APPLICATION NO.	FILING DATE	FIRST NAMED INVENTOR	ATTORNEY DOCKET NO.	CONFIRMATION NO.
10/634,567	08/05/2003	A. Wesley Prais	102-523 DIV/CON/CIP II	6974
32752	7590	05/18/2007	EXAMINER	
DAVID W. HIGHET VP & CHIEF IP COUNSEL SECTION DICKINSON AND COMPANY 1 BECTON DRIVE MC 110 FRANKLIN LAKES, NJ 07417-1880			KOHARSKI, CHRISTOPHER	
		ART UNIT	PAPER NUMBER	
		3763		
		MAIL DATE	DELIVERY MODE	
		05/18/2007	PAPER

Office Action Summary	Application No.	Applicant(s)
	10/634,567	PRAIS ET AL.
	Examiner	Art Unit
	Christopher D. Koharski	3763

DETAILED ACTION

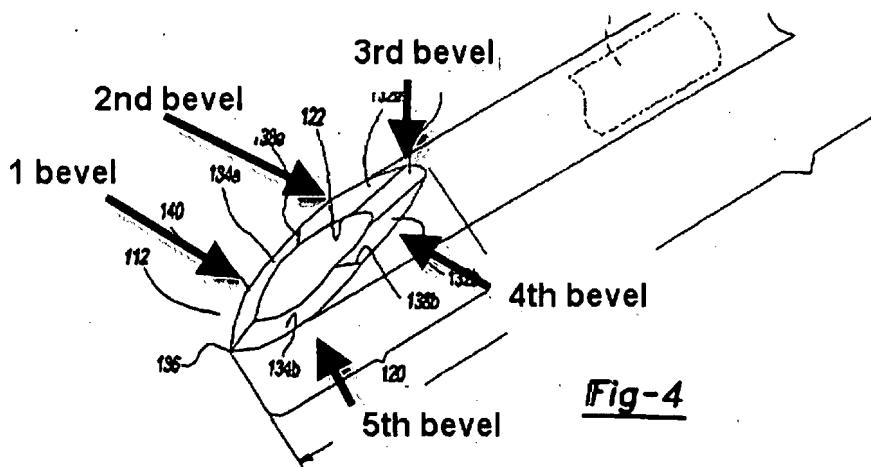
Claim 38 is rejected under 35 U.S.C. 112, second paragraph, as being indefinite for failing to particularly point out and distinctly claim the subject matter which applicant regards as the invention. Amended claim 38 is unclear, the amendment recites the different lengths of each bevel, the claimed lengths are unclear, and Examiner finds no support is Applicant's specification or drawings for the 1-5 bevels (i.e. labeled), following Applicant's terminology (claim 38 text) Examiner assumes (see Applicant's drawing below):

Examiner finds it unclear as to how the first and third bevels each have a length greater than each of said second, forth and fifth bevels. There is no support for the bevel characterization of each bevel (first-fifth), and the length characterization made by Applicant's representative.

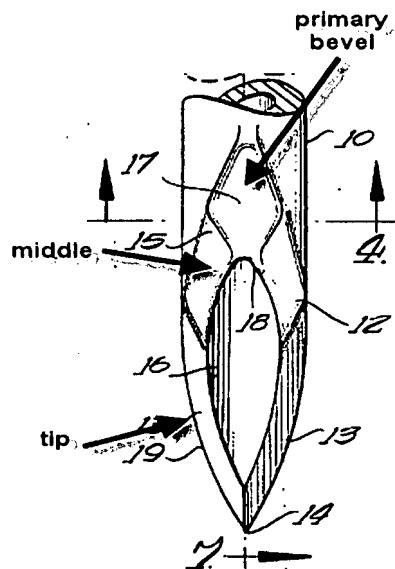
Regarding claims 1-8, 19-25, 28, 31-35 and 38-47, Baldwin et al. discloses a needle cannula comprising a needle (10) with a plurality of planar bevels with different angles relative to the central axis, with a primary bevel (17), a pair of tip bevels (13), and a pair of middle bevels (12) located intermediate to said tip bevel and primary bevel. Additionally the bevels angles with respect to the angles between the bevel angles each bevel has a distinct plane located a specific rotational angle with the planar angles of the primary and middle bevels being substantially equal (Figures 1-5) (see marked figure below).

Additionally, Baldwin et al. discloses multi-bevel point, said cannula having a central axis (along 14) and an outer and inner diameter, said needle cannula having a lumen (near 18) with an opening defining a point (14) with a first, second, third, fourth

and fifth bevels (13, 19, 12, 15, 17)(Figures 1 and 3), said first bevel contiguously extending between said fifth and second bevels, said second bevel contiguously extending between said first and third bevels, said third bevel contiguously extending between said second and fourth bevels, said fourth bevel contiguously extending between said third and fifth bevels, and said fifth bevel contiguously extending between said fourth and first bevels, wherein said first and third bevels each have a greater length than each of said second bevel, said fourth bevel, and said fifth bevel (see Figures 1-4).
